ROAD SAFETY AUDIT CERTIFICATE

**LOCATION: JEANNE D'ARC BOULEVARD NORTH AT FORTUNE
DRIVE/VINEYARD DRIVE – FUNCTIONAL DESIGN, OTTAWA,
ONTARIO**

Location: Jeanne d'Arc Boulevard North at Fortune Drive/Vineyard Drive –
Functional Design, Ottawa, Ontario

| Version | Date | Comments |
|---------|------------------|----------------|
| E01 | February 5, 2024 | Issued for use |

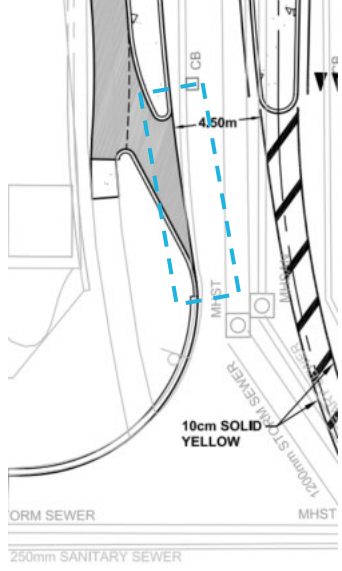
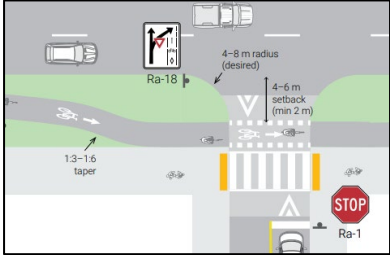
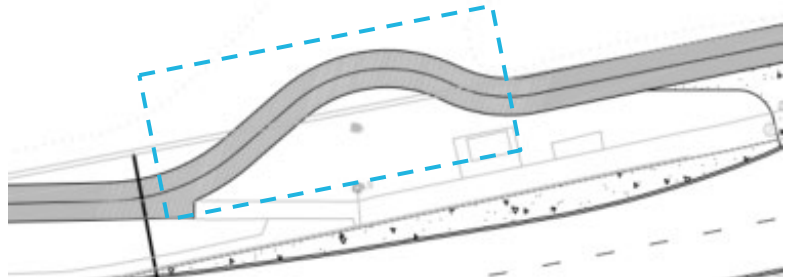
| Issue No. | Issue Description | Critical | Non-Critical | Suggested Mitigation | Owner / Designer Response | Status (Y/N/P) | RSA Team Comments |
|--------------------------------|---|--------------------------|-------------------------------------|---|--|----------------|-------------------|
| 2 | <p><u>Existing walkway connection</u>: the existing walkway connecting Convent Glen Catholic School to Jeanne d’Arc Boulevard is still shown across the boulevard. This may result in motorists blocking the bike lane to load/unload, or pedestrians crossing at midblock locations.</p>  | <input type="checkbox"/> | <input checked="" type="checkbox"/> | <p>Remove the existing walkway connection located on the boulevard.</p> | <p>RCI: To be removed/reconfigured as part of detail design development</p> <p>City: The existing walkway connection has a depressed curb along Jeanne D’Arc Blvd. Consult with EMS and the school to ensure that this paved</p> | Y | No response |

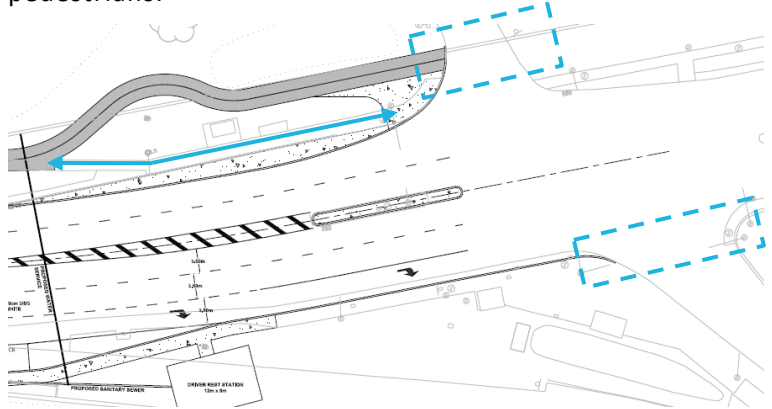
| Issue No. | Issue Description | Critical | Non-Critical | Suggested Mitigation | Owner / Designer Response | Status (Y/N/P) | RSA Team Comments |
|-----------|---|----------|--------------|---|---|----------------|-------------------|
| 3 | <p><u>Discontinuous cycling facilities</u>: the designated cycling facilities terminate outside the extent of the roundabout, where cyclists will mix with general traffic. Visual cues are needed to provide guidance to road users that the designated cycling facilities are terminating, and cyclists will be entering mixed traffic.</p> <p>OTM Book 18 – Cycling Facilities encourages continuity of bicycle facility types, to create better predictability for users. It mentions that a mixed traffic bicycle route is only recommended when the street is low-speed and low-volume.</p>  | ☒ | ☐ | <p>Consider extending the MUP on all approaches to the roundabout to provide a continuous network for cyclists.</p> <p>If the MUP is not extended, provide signage visible to cyclists and motorists clearly indicating start (Wb-10 TAC, Rb-84a, Rb-84t) and the end (Rb-84a, Rb-85t) of the designated cycling facilities.</p> <p>Consider providing arrow pavement markings to indicate where bicycle lanes merge with general traffic lanes, similar to what is shown in MTO Book 18 Figure 6.62:</p>  | <p>RCI: Design to be updated to reflect OTM Boom 18 and City of Ottawa design standards</p> <p>City: Agree. The need for cyclists and drivers to merge traffic should be clearly indicated (e.g., sharrows on the road at the point where cyclists are merging with general traffic).</p> | Y | No response |

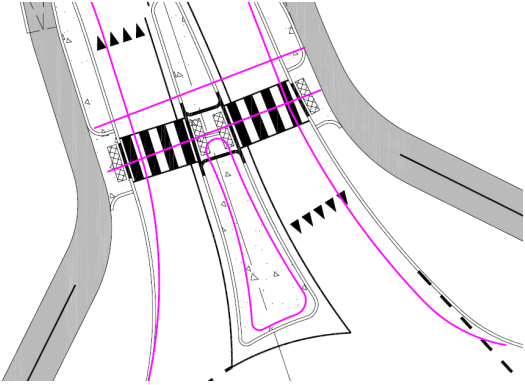
| Issue No. | Issue Description | Critical | Non-Critical | Suggested Mitigation | Owner / Designer Response | Status (Y/N/P) | RSA Team Comments |
|-----------|--|----------|--------------|---|--|----------------|-------------------|
| 4 | <p><u>Cycle track to MUP transitions</u>: on all cycle track transitions from the roadway to the MUP, there is potential for conflicts between cyclists accessing the MUP and pedestrians.</p>  | ☒ | ☐ | <p>Install “Bicycles Yield to Pedestrians” signage for cyclists heading from the roadway to the MUP, along with cyclist yield markings.</p> | <p>RCI: Signage to be reviewed/refined with City of Ottawa during detail design process.</p> <p>CITY: Signage could also be provided for pedestrians (and cyclists) entering the MUP from the road crossing to look both ways for cross traffic.</p> | Y | No response |
| 5 | <p><u>MUP/cycle tracks transitions – pedestrians</u>: on all cycle tracks transitions between the MUP and the roadway, there is potential for pedestrians travelling on the MUP to follow the cycle track and end up on the roadway.</p> | ☐ | ☒ | <p>Provide arrows and bike stencils on the cycle track to indicate the intended use by cyclists only.</p> <p>Consider providing arrows and pedestrian stencils on the portion of the cycle track connecting to the sidewalk.</p> <p>Install attention TWSIs within the ramp to advise pedestrians that they are leaving the sidewalk.</p> <p>Install directional TWSIs at the edge of the MUP to advise pedestrians of the correct direction of travel.</p> | <p>RCI: Cycle ramp transitions and TWSI layouts to be developed during detail design refinement in accordance with City of Ottawa standards</p> <p>CITY: No comment</p> | Y | No response |

| Issue No. | Issue Description | Critical | Non-Critical | Suggested Mitigation | Owner / Designer Response | Status (Y/N/P) | RSA Team Comments |
|-----------|--|----------|--------------|---|---|----------------|-------------------|
| |  | | | <p>Example:</p>  <p>Where no sidewalk is provided beyond the MUP, provide signage advising pedestrians that the sidewalk and MUP end, and they should cross to the other side.</p> | | | |

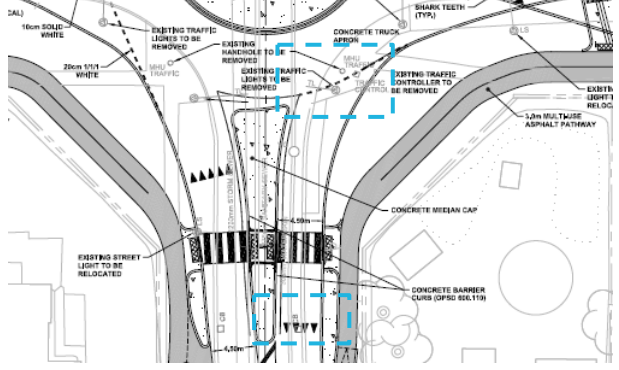
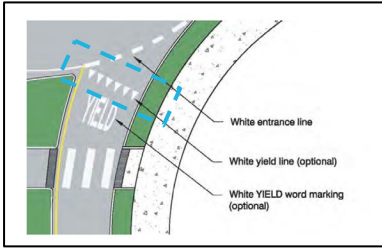
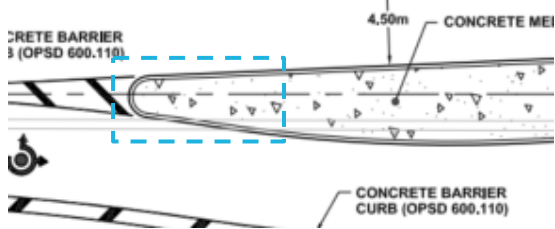
| Issue No. | Issue Description | Critical | Non-Critical | Suggested Mitigation | Owner / Designer Response | Status (Y/N/P) | RSA Team Comments |
|-----------|--|--------------------------|-------------------------------------|---|---|----------------|--|
| 8 | <p><u>Rodway to cycle track transition</u>: the eastbound cycle track access on Vineyard Drive is on the inside of the horizontal curve. The access may not be visible to cyclists. In addition, the relatively short length and narrow width of taper would require cyclists to access the bicycle facility on a shallow angle.</p> | <input type="checkbox"/> | <input checked="" type="checkbox"/> | Provide advance signage advising cyclists and motorists of the start of the cycling facility. | RCI: Cycle transitions and signage to be reviewed/refined with City of Ottawa during detail design process | Y | No response |

| Issue No. | Issue Description | Critical | Non-Critical | Suggested Mitigation | Owner / Designer Response | Status (Y/N/P) | RSA Team Comments |
|-----------|--|----------|--------------|--|---|----------------|--------------------|
| |  | | | <p>Ensure that a level surface is provided to minimize the risk of cyclists losing control when accessing the cycle track.</p> <p>Consider lengthening the on-road horizontal transition to provide a better opportunity for cyclists to safely access the cycle track.</p> | <p>CITY: No comment</p> | | |

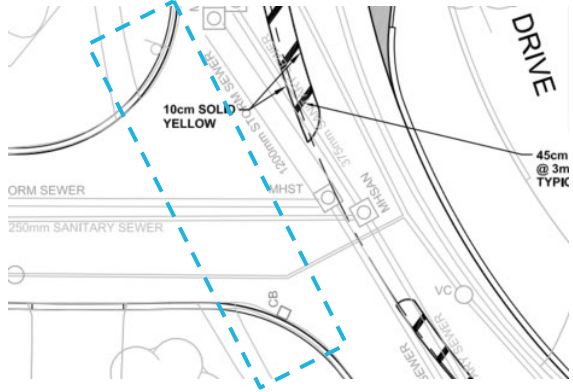
| Issue No. | Issue Description | Critical | Non-Critical | Suggested Mitigation | Owner / Designer Response | Status (Y/N/P) | RSA Team Comments |
|-----------|--|----------|--------------|--|---|----------------|--------------------|
| 9 | <p><u>Cycle track to roadway transition on Vineyard Drive</u>: cyclists travelling westbound on Vineyard Drive transition to the roadway just prior to Medoc Court. This may lead to conflicts with motorists turning to and from Medoc Court.</p> | ☒ | ☐ | <p>Consider extending MUP along Vineyard Drive to provide a more connected cycling network.</p> <p>If not possible, extend MUP past Medoc Court. At the intersection, consider providing crosswalk and crossroad markings, and signage for westbound right-turning motorists to yield to through cyclists. There may be an opportunity to provide a setback crossing at the intersection, similar to the</p> | <p>RCI: Cycle transitions and signage to be reviewed/refined with City of Ottawa during detail design process</p> <p>CITY: No comment</p> | Y | <p>No response</p> |

| Issue No. | Issue Description | Critical | Non-Critical | Suggested Mitigation | Owner / Designer Response | Status (Y/N/P) | RSA Team Comments |
|-----------|--|--------------------------|-------------------------------------|--|--|----------------|-------------------|
| |  | | | <p>configuration shown in OTM Book 18 Figure 6.30:</p>  | | | |

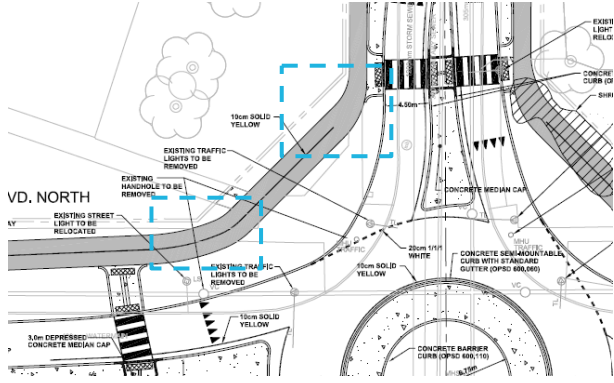
| Issue No. | Issue Description | Critical | Non-Critical | Suggested Mitigation | Owner / Designer Response | Status (Y/N/P) | RSA Team Comments |
|-----------|--|--------------------------|-------------------------------------|--|--|----------------|-------------------|
| 10 | <p><u>Horizontal curve in the MUP</u>: there are horizontal curves with short radii on the MUP located on the east side of Jeanne d'Arc Boulevard, north of the intersection with Highway 174 ramps. This may result in cyclists having difficulties navigating the curves.</p>  | <input type="checkbox"/> | <input checked="" type="checkbox"/> | <p>Consider increasing the curve radii of the MUP to provide greater comfort for cyclists.</p> | <p>RCI: MUP designed and built by others. No changes to be made under this project</p> <p>CITY: No comment</p> | N | No response |

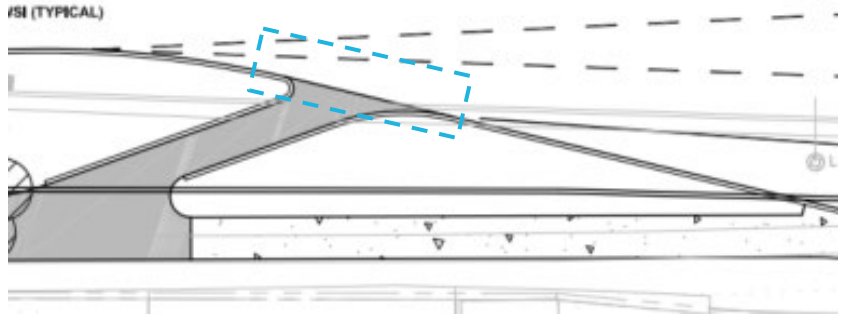
| Issue No. | Issue Description | Critical | Non-Critical | Suggested Mitigation | Owner / Designer Response | Status (Y/N/P) | RSA Team Comments |
|-----------|--|-------------------------------------|-------------------------------------|---|---|----------------|-------------------|
| 12 | <p><u>Single-stage crossing:</u> providing a single-stage crossing for the crosswalk at Fortune Drive would require pedestrians to cross both the entry and exit lanes of the roundabout at the same time. This considerably increases the crossing distance and requires pedestrians to cross two directions of traffic at once.</p> <p>While a PXO Type C crossing is proposed to provide additional pedestrian right of way, motorists may not be anticipating the need to stop, especially those in the exit lane. This could result in conflicts</p> | <input checked="" type="checkbox"/> | <input type="checkbox"/> | <p>A single-stage crossing is not recommended at a roundabout, especially near an elementary school. Splitter islands serve different roles at roundabouts, including providing refuge for pedestrians and allowing them to cross each direction of</p> | <p>RCI: Noted. Per discussion with City of Ottawa, 2 stage crossings to be maintained.</p> <p>CITY: The design already proposes a 2-stage crossing;</p> | Y | No response |

| Issue No. | Issue Description | Critical | Non-Critical | Suggested Mitigation | Owner / Designer Response | Status (Y/N/P) | RSA Team Comments |
|-----------|---|--------------------------|-------------------------------------|---|--|----------------|-------------------|
| | <p>between pedestrians and motorists. This issue is compounded by the fact that an elementary school is located on the northeast corner of the intersection.</p>  | | | <p>traffic separately, making it easier to find a gap in traffic and concentrate on detecting vehicles arriving from one direction.</p> | <p>therefore, the suggested mitigation is not required.</p> | | |

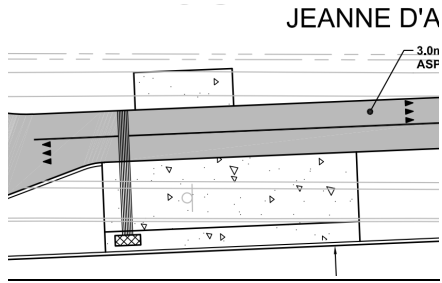
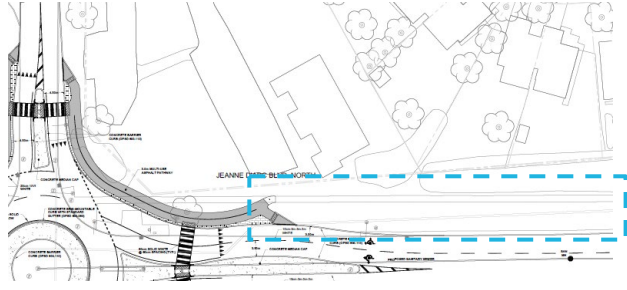
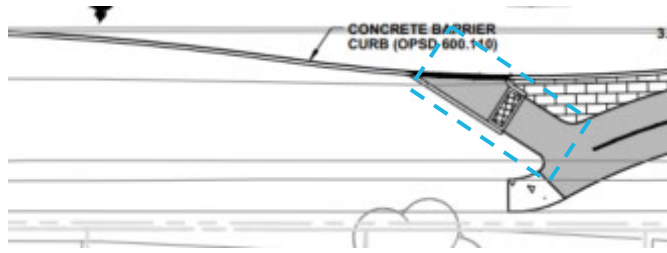
| Issue No. | Issue Description | Critical | Non-Critical | Suggested Mitigation | Owner / Designer Response | Status (Y/N/P) | RSA Team Comments |
|-----------|---|--------------------------|-------------------------------------|---|--|----------------|-------------------|
| 13 | <p><u>Roundabout yield markings</u>: While entering a roundabout, motorists face yield conditions in two locations that are several metres apart: before the crosswalk, and again before entering the roundabout. Although both locations are at conflict points and require the motorist to yield, pavement markings in these two locations are different.</p> | <input type="checkbox"/> | <input checked="" type="checkbox"/> | <p>Although optional, consider providing a second yield line on all entry lanes, at the edge of the circulating lane to provide markings consistency for motorists.¹</p> <p>Example:</p> | <p>RCI: City of Ottawa pavement marking standards do not include perpendicular yield lines (shark's teeth) at roundabout entry.</p> <p>CITY: Pavement markings should be consistent with</p> | N | No response |

| Issue No. | Issue Description | Critical | Non-Critical | Suggested Mitigation | Owner / Designer Response | Status (Y/N/P) | RSA Team Comments |
|-----------|--|----------|--------------|---|--|----------------|-------------------|
| |  | | |  | <p>pavement markings at other roundabouts within the City of Ottawa for driver expectancy. Consider yield symbol pavement markings.</p>   | | |

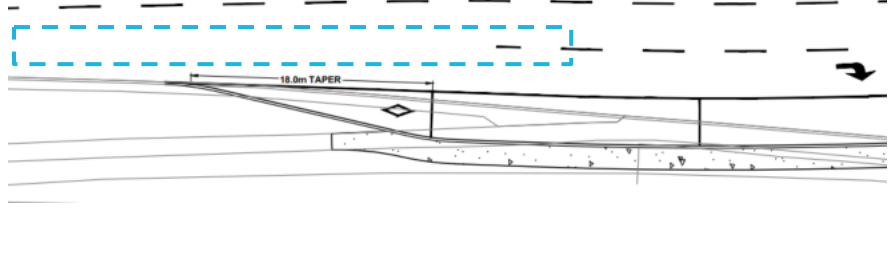
| Issue No. | Issue Description | Critical | Non-Critical | Suggested Mitigation | Owner / Designer Response | Status (Y/N/P) | RSA Team Comments |
|-----------|--|----------|--------------|---|--|----------------|-------------------|
| 14 | <p><u>Concrete medians</u>: the concrete median on each intersection approach presents a hazard for motorists entering the roundabout.</p>  | □ | ☒ | <p>Provide “keep right” and “object marker” signs on the median to advise motorists of the roadway hazards for all roundabout approaches.</p> | <p>RCI: Object markers and Keep right signage to be provided. Signage to be refined as part of detail design process.</p> <p>CITY: No comment</p> | Y | No response |

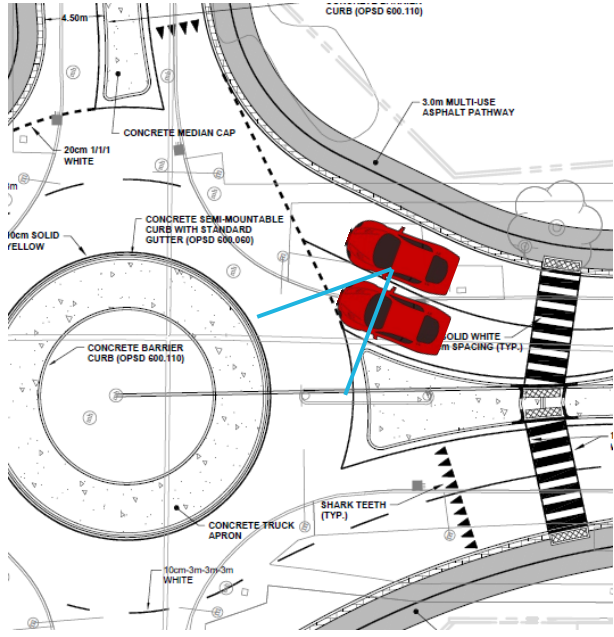
| Issue No. | Issue Description | Critical | Non-Critical | Suggested Mitigation | Owner / Designer Response | Status (Y/N/P) | RSA Team Comments |
|-----------|---|--------------------------|-------------------------------------|--|---|----------------|-------------------|
| 16 | <p><u>Medoc Court intersection configuration</u>: the wide intersection width and large curb radius at Vineyard Drive and Medoc Court can result in high vehicle turn speeds and longer pedestrian crossing distance. In addition, the current configuration is not fully perpendicular to Vineyard Drive, which can impact sightlines for turning motorists.</p>  <p>The diagram shows a plan view of the intersection between Medoc Court and Vineyard Drive. A dashed blue line indicates the proposed curb radius reduction. Labels include '10cm SOLID YELLOW' for the curb, '45cm @ 3m TYPK' for the curb radius, 'ORM SEWER', '250mm SANITARY SEWER', 'MHST', 'VC', and 'DRIVE'.</p> | <input type="checkbox"/> | <input checked="" type="checkbox"/> | <p>Reduce curb radius at the intersection using curb extensions. The smallest possible corner radius should be provided to reduce vehicle turn speeds as much as possible. Given the land uses on Medoc Court, the intersection corner radius could be reduced considerably.</p> <p>Use the curb radius reduction to align motorists more perpendicular to Fortune Drive to improve sightlines.</p> <p>Provide ladder crosswalk markings to improve visibility of the crosswalk.</p> | <p>RCI: Curb radii to be reviewed with City of Ottawa during detail design process</p> <p>CITY: No comment</p> | Y | No response |

| Issue No. | Issue Description | Critical | Non-Critical | Suggested Mitigation | Owner / Designer Response | Status (Y/N/P) | RSA Team Comments |
|---|--|-------------------------------------|-------------------------------------|---|--|----------------|-------------------|
| | | | | Add a crossride, as indicated in Issue 9. | | | |
